Access Compliance Report

Public Rights-of-Way

(Curb Ramps)

Intersection ID: 19665	Main Street: BROWN-GRIER_RD	Cross Street: WILD_DOGWOOD_CT	Location: NW
ADA ID: 2D952452D4D5	Ramp Type: BlendTrans2	Initial Pass/Fail: Pass	Overall Compliance: No
Severity Score: 10.25			
Codes/Mitigation Info/Possible Solution		Field Measurements/Component Compliance

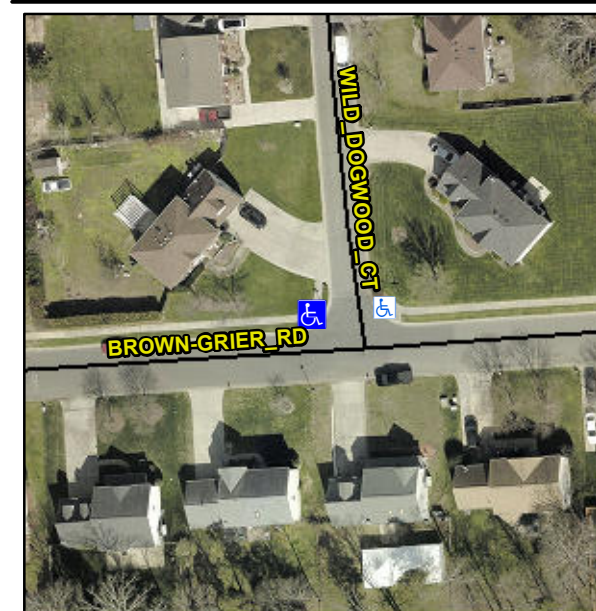
Not Found, R304.5.3, R305

Compliance	Description	Data	Compliance	Description	Data
N/A	Ramp Length (in)	86.0	Yes	BlendTrans Slope (%)	1.9
Yes	Ramp Width (in)	48.0	No	BlendTrans XSlope (%)	2.3
N/A	Flare Type LT	None	N/A	Flare Type RT	None
N/A	Flare Slope LT (%)	N/A	N/A	Flare Slope RT (%)	N/A
N/A	Flare Traversable LT?	N/A	N/A	Flare Traversable RT?	N/A
N/A	Landing Length (in)	N/A	No	DWS Provided?	No
N/A	Landing Width (in)	N/A	N/A	DWS Contrast?	No
N/A	Landing Slope (%)	N/A	N/A	DWS Length (in)	N/A
N/A	Landing X Slope (%)	N/A	N/A	DWS Full Width?	No
N/A	Landing Curb? (Y/N)	No	N/A	DWS Offset (in)	N/A
N/A	Shared Landing?	No			
Yes	Gutter Ponding?	No	Yes	Gutter Slope (%)	1.5
Yes	Gutter Lip Ht (in)	0.0	No	Gutter X Slope (%)	2.1
N/A	Painted X Walk1?	No	N/A	Painted X Walk2?	No
	X Walk 1 Direction	To S		X Walk 2 Direction	To E
	X Walk 1 Width (in)	N/A		X Walk 2 Width (in)	N/A
	X Walk 1 Slope (%)	4.1		X Walk 2 Slope (%)	0.8
	X Walk 1 X Slope (%)	1.0		X Walk 2 X Slope (%)	2.3

N/A	Ramp inside XWalk1?	N/A	N/A	Ramp inside XWalk2?	N/A
	Road Slope (%)	2.0		Clear Space?	Yes
	Road X Slope (%)	1.9	N/A	Clear Space to XWalk (in)	N/A
Yes	Any Obstructions?	No	Yes	Storm Grate/Utility Hazard?	No
	Obstruction Type			Storm Grate/Utility Type	
		N/A			N/A
			Yes	Surface Condition? (G/P)	Good
			No	Curb Slope (%)	10.4

Remove & Replace Curb Ramp With Two New Directional Ramps or Equivalent. Remove & Replace Gutter.
